STATE OF NORTH CAROLINA
DEPARTMENT OF TRANSPORTATION

June 26, 2019

Subject: **Request for Modification to Individual Section 404 and Section 401 Water Quality Certification** for the Winston-Salem Northern Beltway Interchange at US 52 (Future I-74), Forsyth County. Federal Aid Project No. NHP-0074(213), TIP Nos. R-2247EB. Division 9. Debit \$570 from WBS 34839.3.GV7

FIGURE 3
Project Limits
With Section
Changes

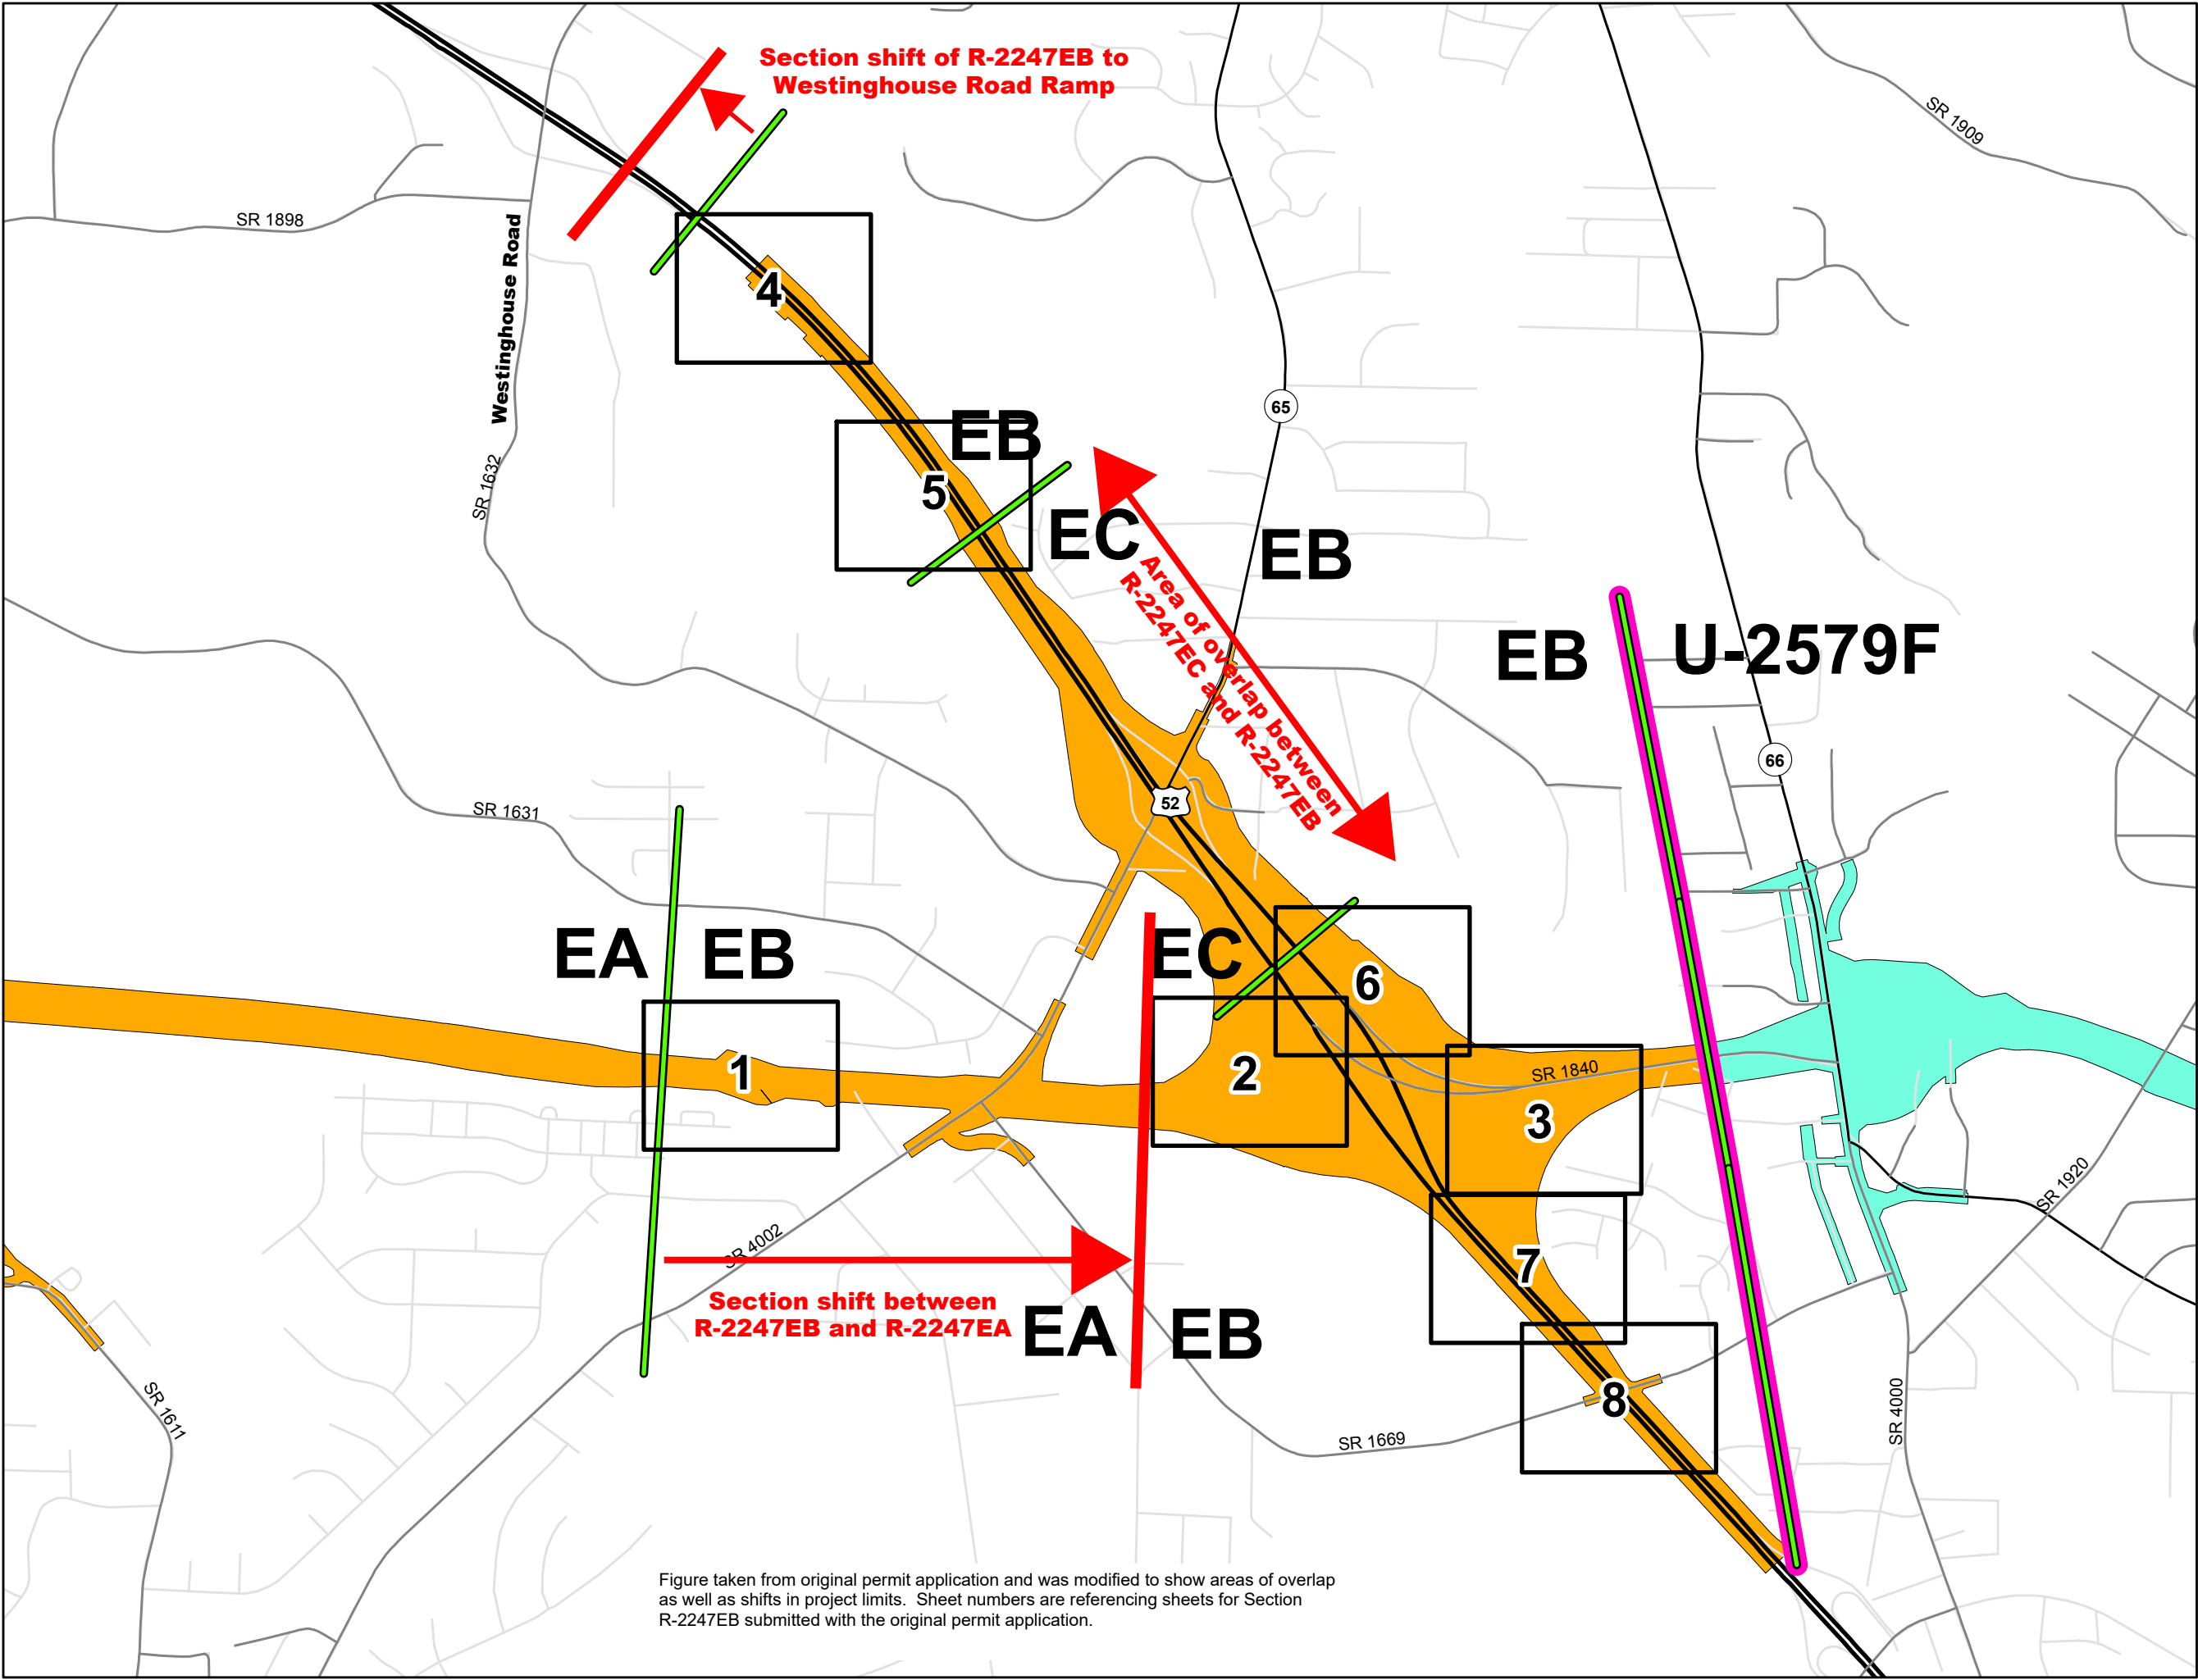
PROJECT LIMIT UPDATES - Over the elapsed time period from the original permit to today the Department of Transportation revised the project limits of the R-2247EB and R-2247EA projects. Figure 3 illustrates the updated project limits. Specifically the western limit of R-2247EB has been shifted east of NC 65 effectively shortening R-2247EB in the east-west direction. This has the effect of lengthening the R-2247EA project by shifting its end point further east (east of NC 65). Additionally the R-2247EB project was extended to the ramp gore area of the Westinghouse Road interchange which is north of the original permit project limits as shown on Figure 3.

Figure taken from original permit application and was modified to show areas of overlap as well as shifts in project limits. Sheet numbers are referencing sheets for Section R-2247EB submitted with the original permit application.

FIGURE 4

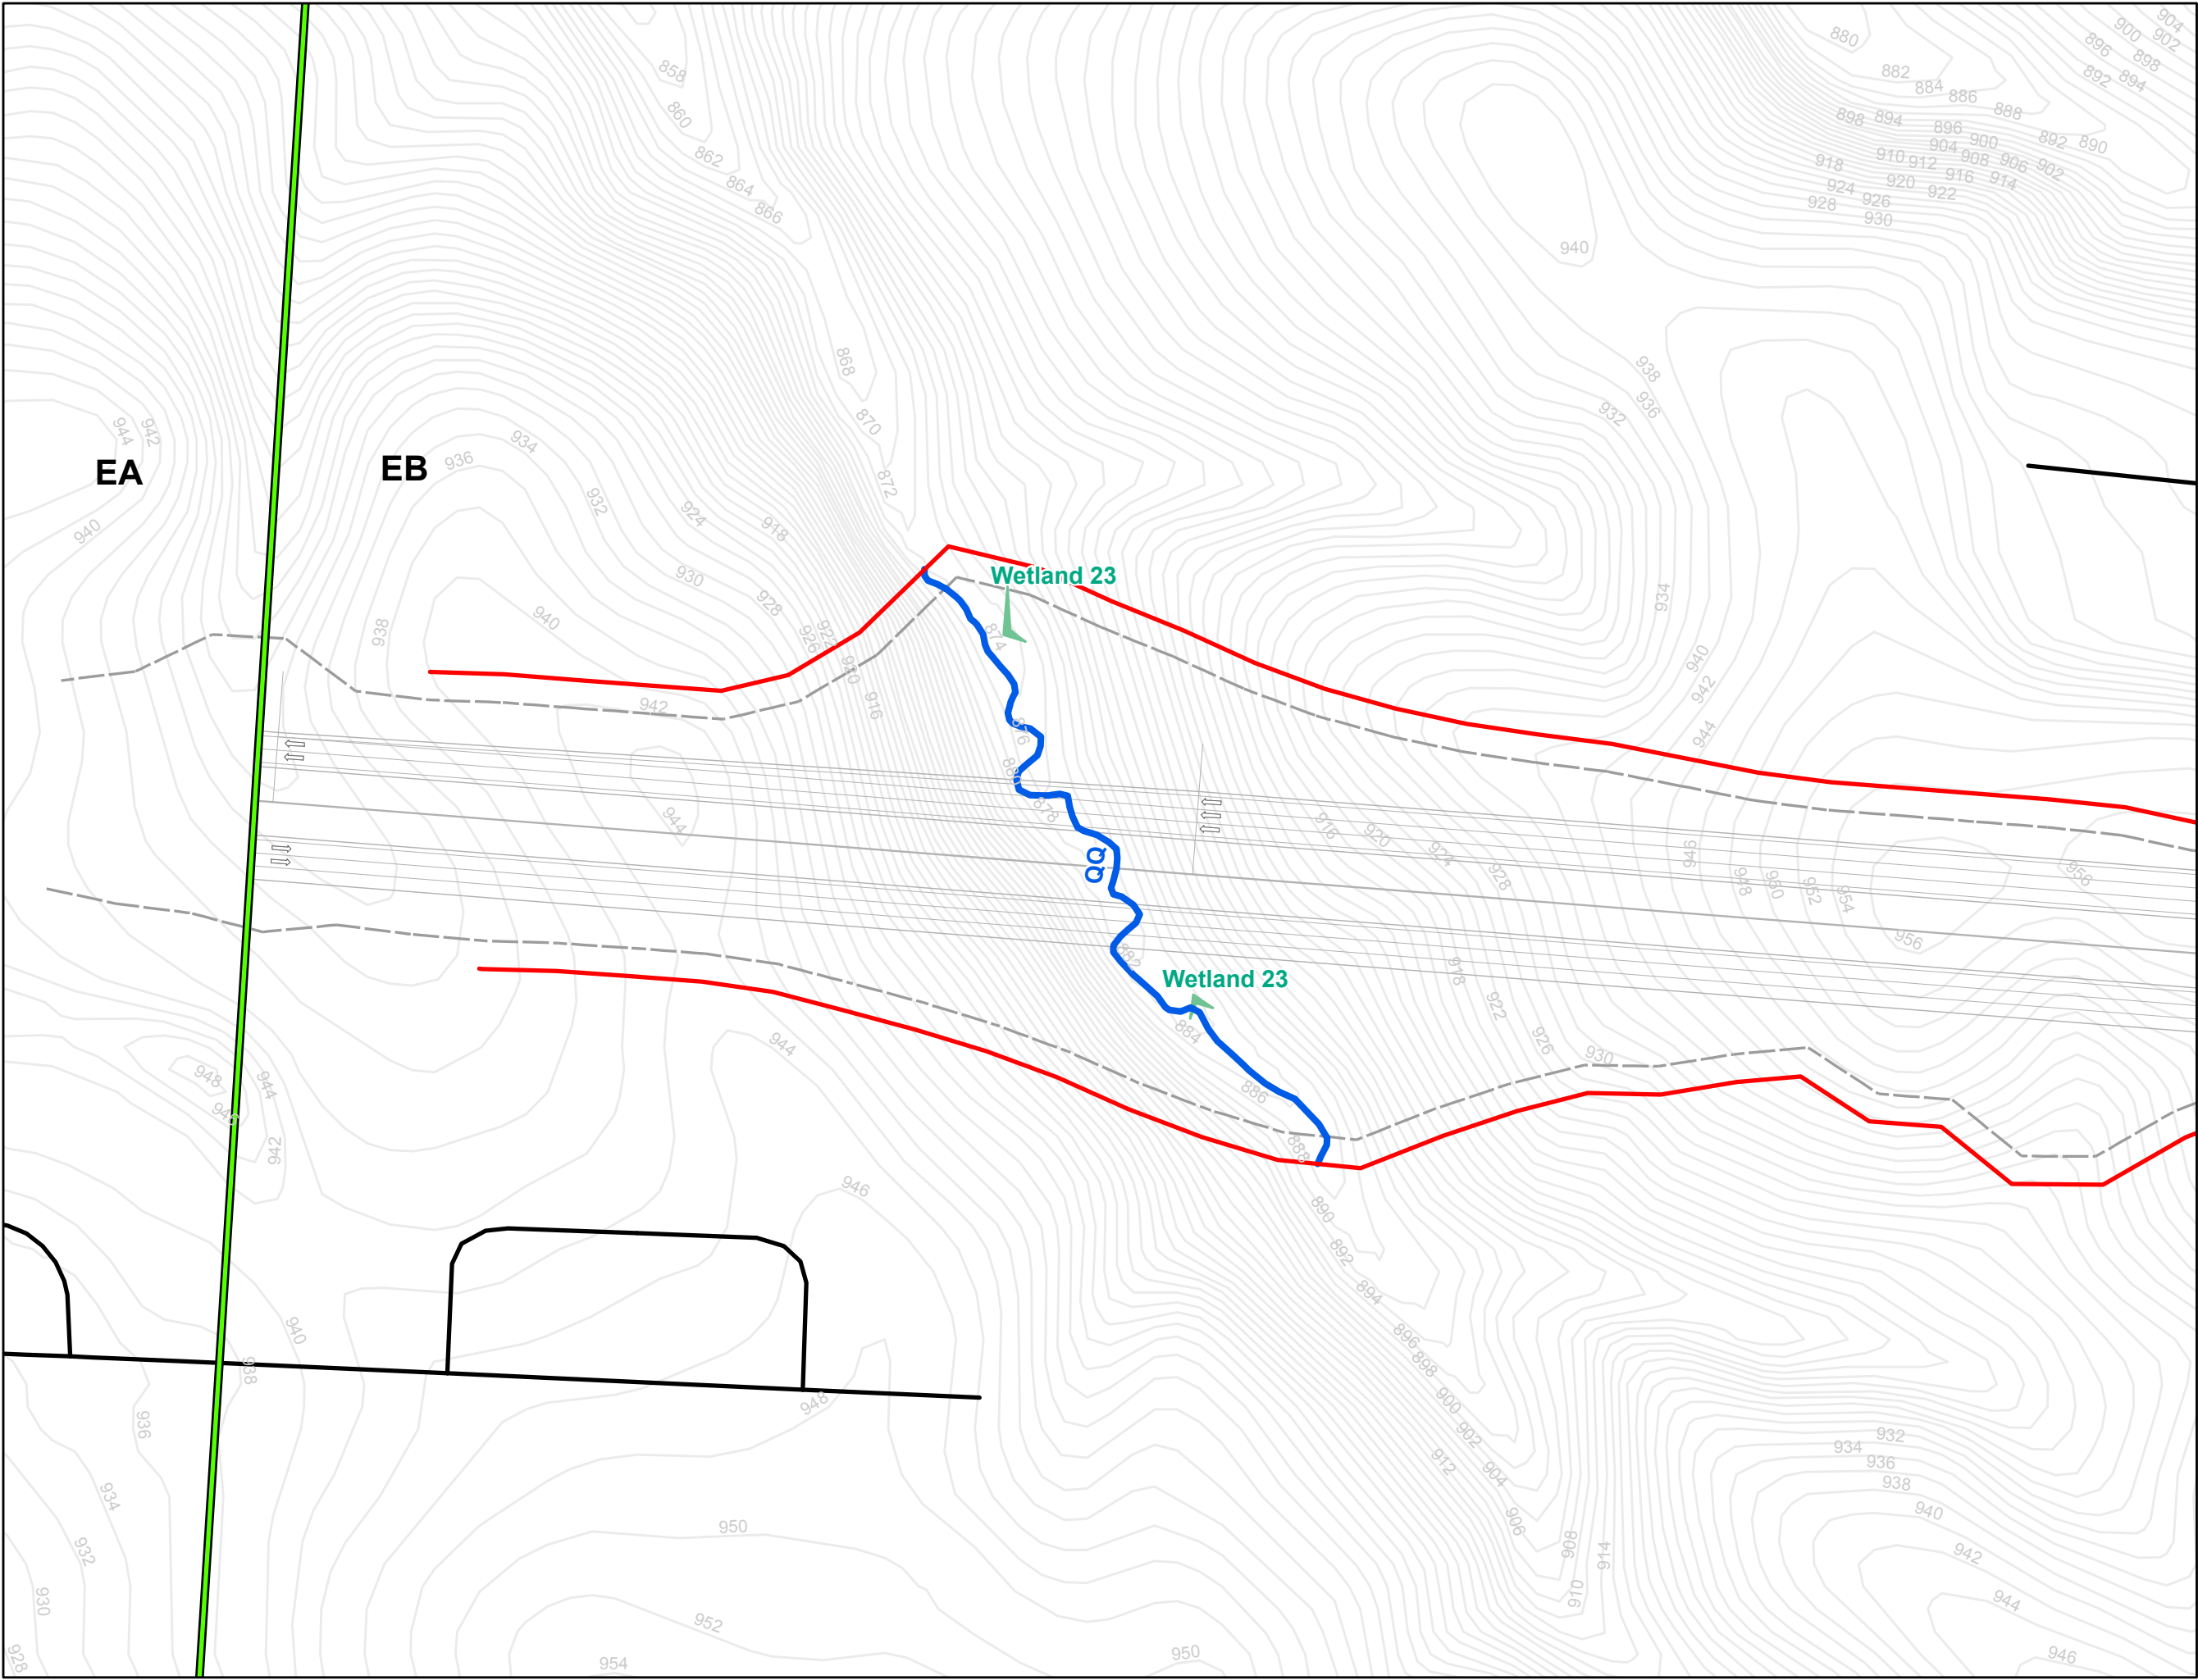
The original permit impact identification/tabulation included wetland impacts of 0.01acre at wetland 23 and 774 lf of impacts to stream QQ (Figure 4). As these impacts are no longer within the R-2247EB project limits they will shift to the R-2247EA project as illustrated in the permit impact narrative and tables in other sections of this document. The design of the project did not impact jurisdictional features within the short northern extension along US 52.
